Technical Note Title: Pilsworth South MRF

Subject: Foul and Surface Water Drainage relating to Planning Permission 71273

Reference: ECL.9595.R05.002 Rev 0

Date: 20.06.2025

MRF Building
Drainage

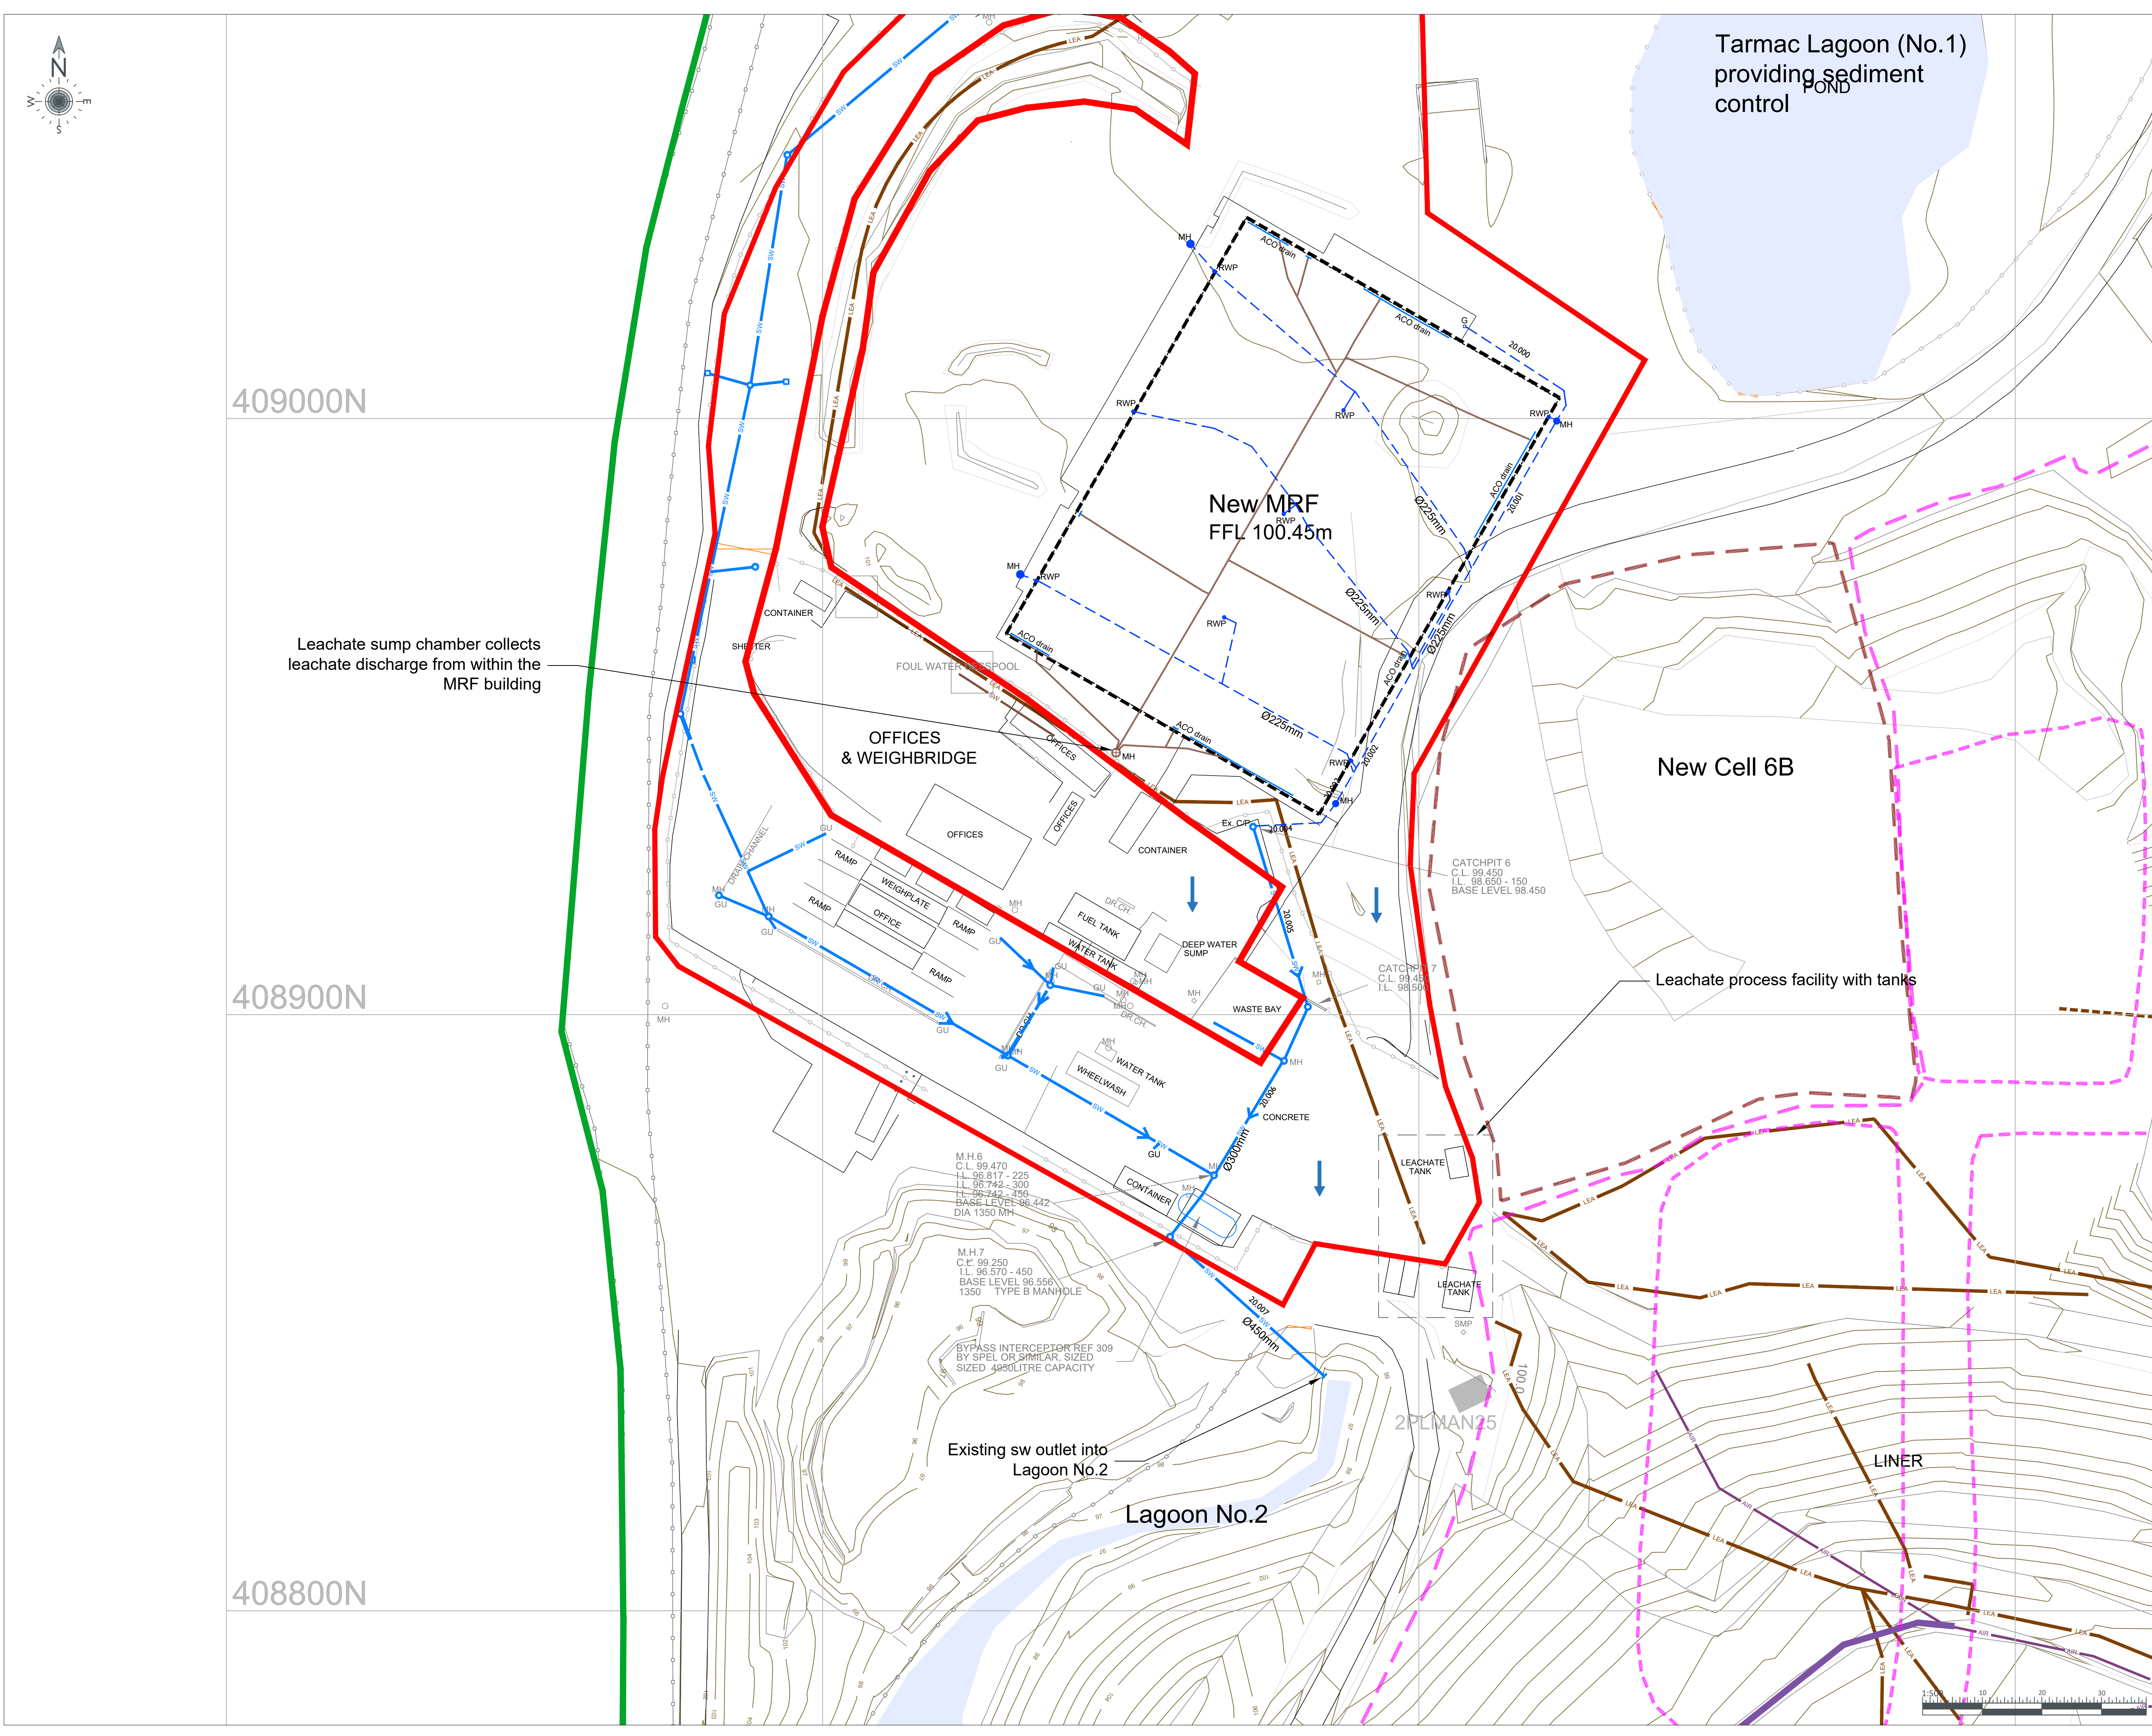
United Utilities has reviewed the submitted information and recommends that condition 3 is not discharged. This is because there is no determining factor where foul or surface water drains from or to the drainage plan. Accordingly, the details submitted do not satisfactorily address the requirements of the condition and therefore the condition is not discharged.

- 2.2 The location of the new MRF sited at a relatively high level is conducive to utilising the nearest existing Lagoon No. 2; this is located to the south of the office/weighbridge compound. The proposed connection of the MRF drainage is to an existing chamber on the northern edge of this compound. This existing SW network serves other hard surfaces within the compound including hardstandings and roofs.

- 2.4 The use of infiltration systems is not practical given the presence of the existing SuDS relatively close to the new MRF. Furthermore, the longer term use of land immediately adjacent the MRF is intended to be for further cell development. This cell expansion will likely be undertaken as part of the final landfill works at a later stage.
- 2.5 The updated MRF Building Drainage Plan is provided in Appendix 2.

- 3.1 The new MRF building drainage includes new leachate drainage, this drainage intercepts leachate, albeit low in volume, from within the building via channel drains. This is conveyed to a sump chamber on the southern end of the building. The leachate will drain to this sump chamber and be tankered off site. In the event of a fire where there will be a larger volume of leachate/firewater, this may be recirculated through the system to help suppress the fire but will still ultimately be tankered off site to a suitably licenced facility.
- 3.2 The leachate drainage system for the MRF building does not discharge to the SW network nor the existing leachate collection and treatment system for the landfill.
